**PB# 90-26**

**WINDSHIRE  
AMENDED SP**

**SUBJECT: WINDSHIRE ESTATES AMENDED SITE PLAN  
NEW WINDSOR PLANNING BOARD 90-26**

## "AMENDED LAYOUT & AS-BUILT PLAN"

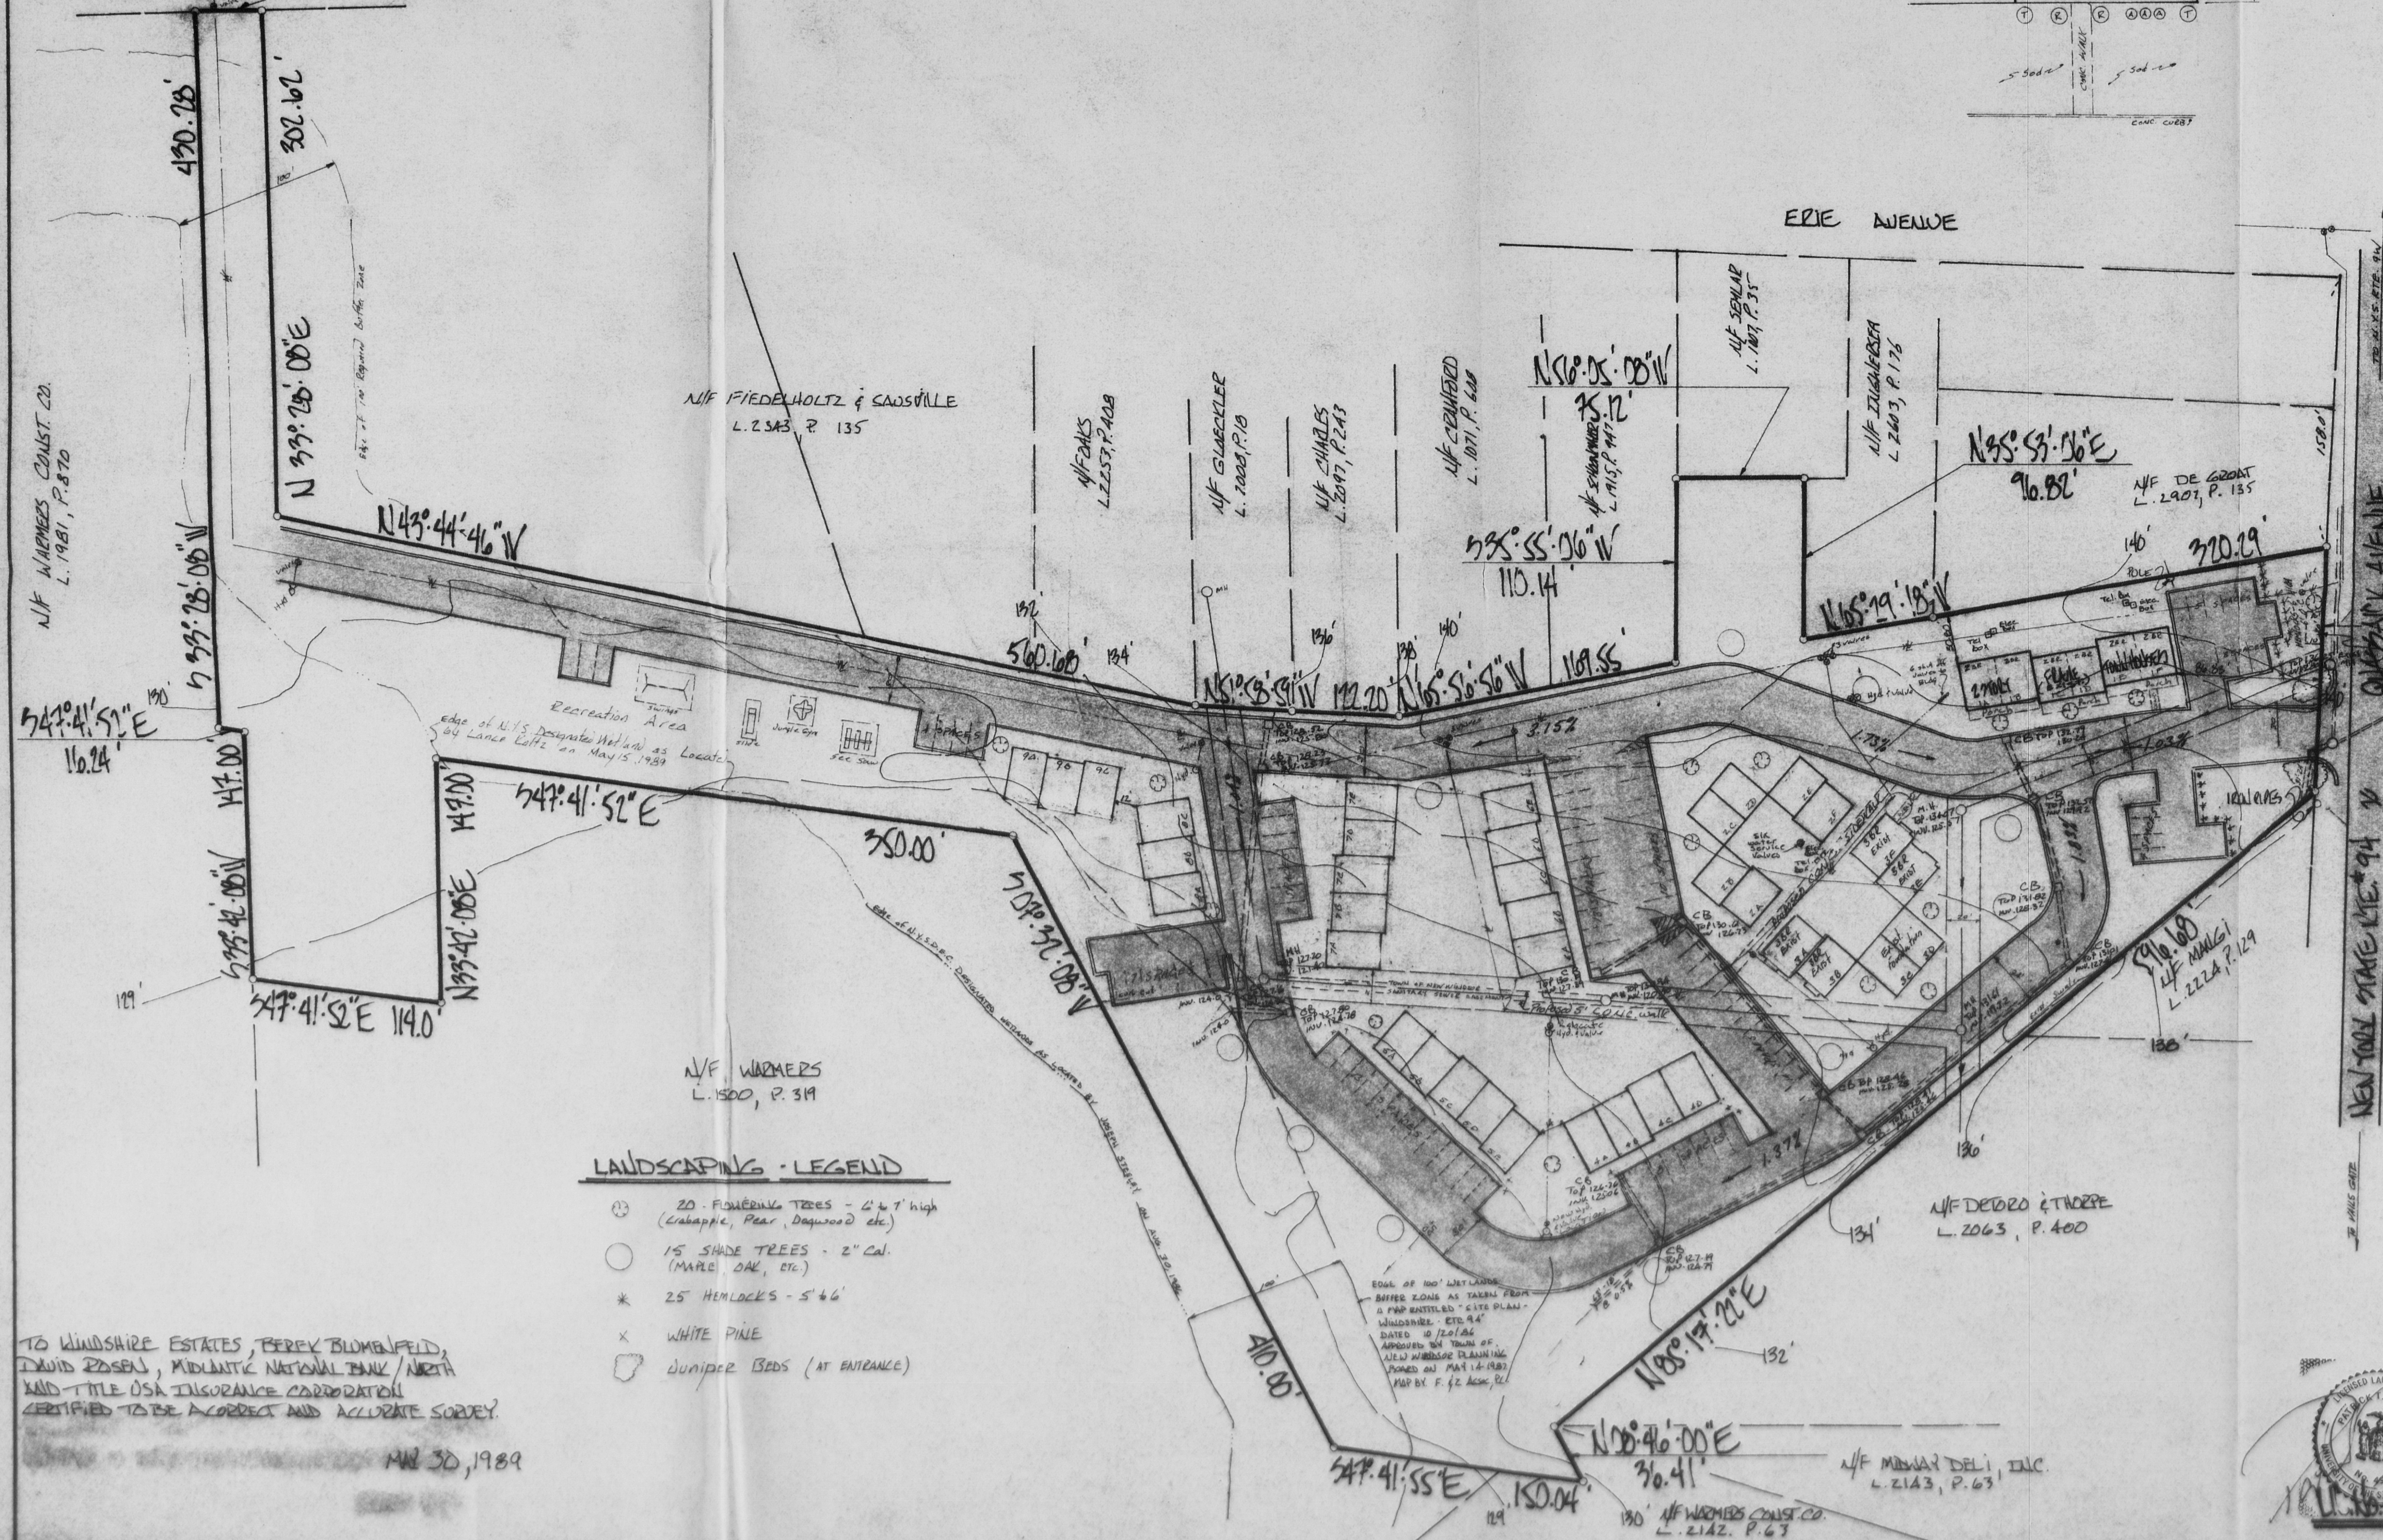
MR. SCHIEFER: We have water approval, sanitary approval, we have fire disapproved May 4th. Fire hydrant located in the middle of lawn to be relocated. Just wanted you to be aware of it.

MR. SOUKUP: I don't think the table is right on the two bedroom counts. Table on the right hand side right underneath.

MR. EDSALL: The question that I believe it was Vince that brought up as far as the number of 3 bedroom versus the number of 2 bedroom, which is right?

MR. VAN LEEUWEN: The way I see it we have a problem with 7E and we have got a little bit to many bedrooms.

MR. MC CARVILLE: Pat, 3C, 3D, 3E, 3F, those people, where are they going to park? Do you think they are going to park in the lot they are going to park right in front of the units on the street. If you live in 3D, you have to park way over on the other side of that complex. You are going to have to tote your groceries and stuff from over there, it almost looks like two of these units should be swapped and put some parking.

MR. SCHIEFER: Take off 7 bedrooms, add 4 parking places up in this area and what about this place for the kids.

This site plan is rejected until the fire hydrant located in the middle of the lawn is moved to an accessible location.

- a. The site location map on sheets W1 and W2 does not indicate the proper site location. Please correct.
- b. The legend on sheet W2 is incomplete. Please include the symbols for new catch basins, water valves and concrete thrust blocks.
- c. Show the meter/PRV chambers on the plan view.
- d. The maximum allowable separation between valves is 800'. A valve is required between the valve station 8+83 and wet tap #2. Please revise.
- e. Several of the bends shown on the plans do not conform with standard bends and may indicate excessive deflection. Please label the bends that are intended to be installed, and show deflection at other joints if required.
- f. The hydrant at station 8+83 is shown less than 10' from a sewer lateral. Please revise.
- g. Indicate the size of the existing waterline in Erie Ave.

I have made a review of the minutes for the subject project, for the meeting of 8 August 1990, at which time the Planning Board granted conditional final site plan approval. Based on my review of the minutes, it appears that the only change required was a relocation of a fire hydrant so as to comply with the recommendation of the Fire Inspector's office. This change has been made on the plan; therefore, it is my opinion that the plan is acceptable for stamp approval.
